MONTICELLO NUCLEAR GENERATING PLANT

Core Operating Limits Report

for Cycle 18

Revision 1

Figure 3
 Monticello Cycle 18
 Power Dependent CPR Limits

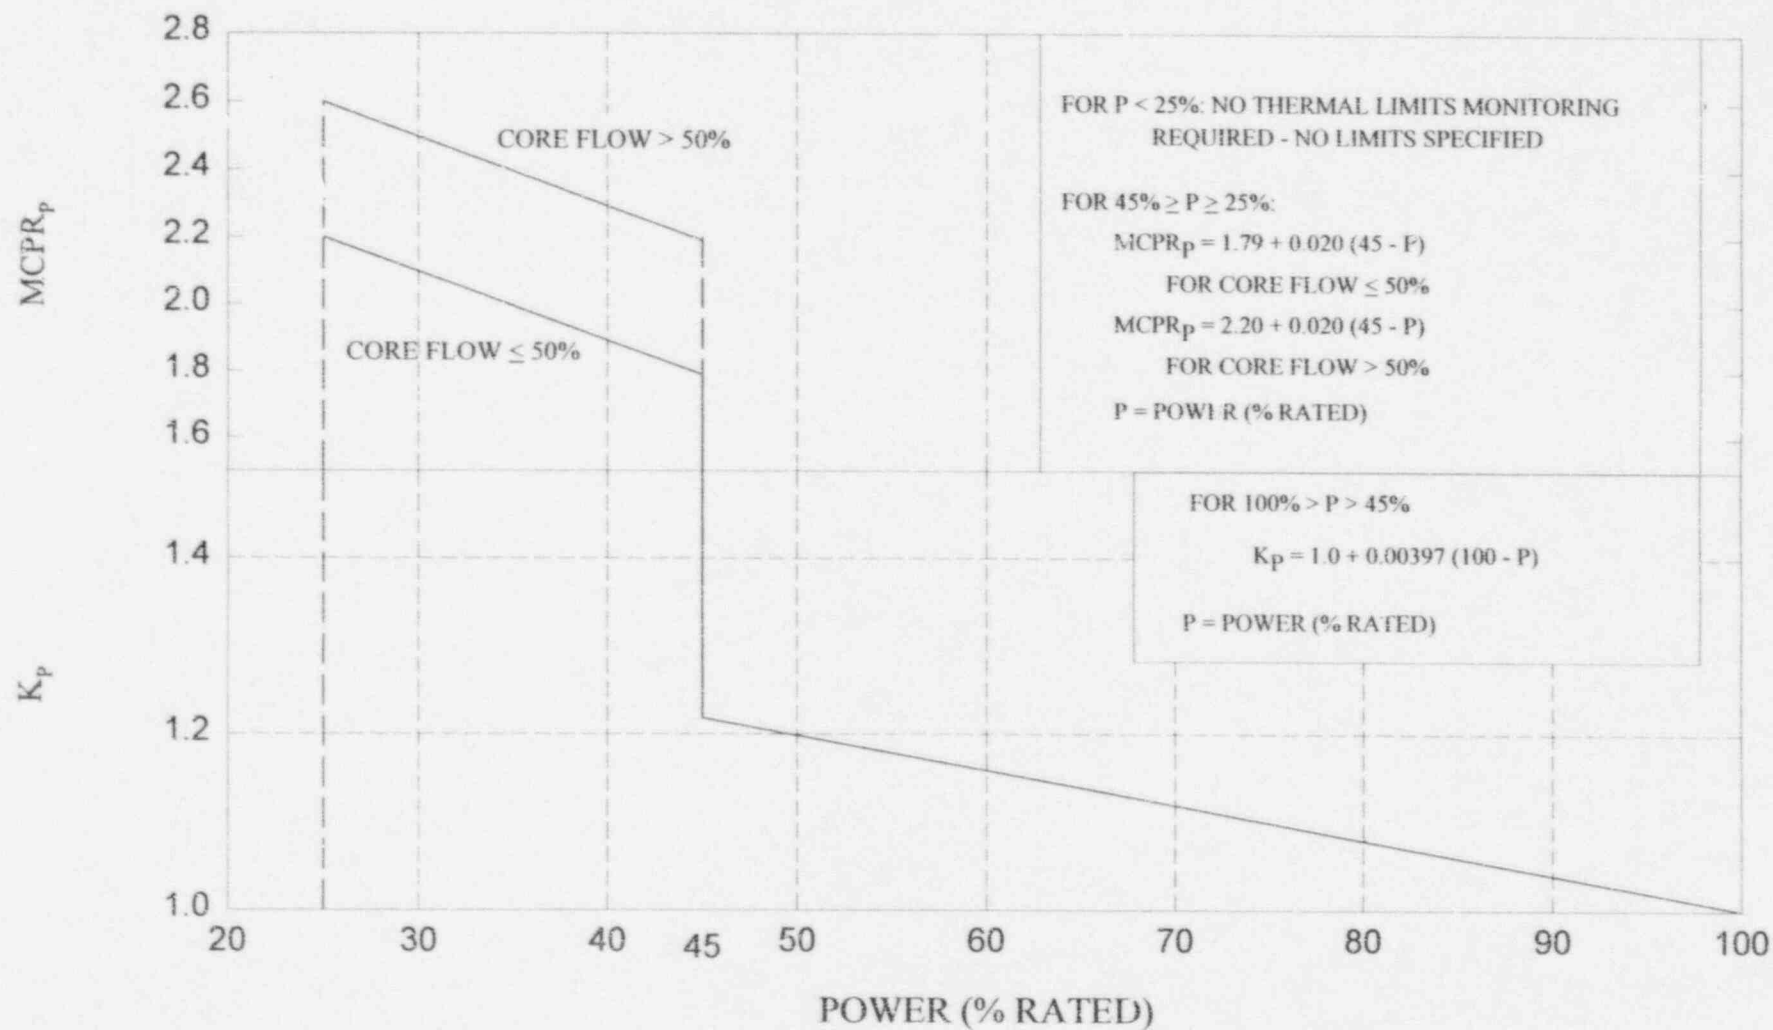
This report complies with the verbal agreement between GE and the NRC with regard to modification of the MCPR operating limits (Reference 1) to reflect the 0.01 change in SLCPR for Monticello Cycle 18. Also, the power and flow dependent MCPR curves (Figure 3 and Figure 4) account for the 0.01 change in SLCPR.
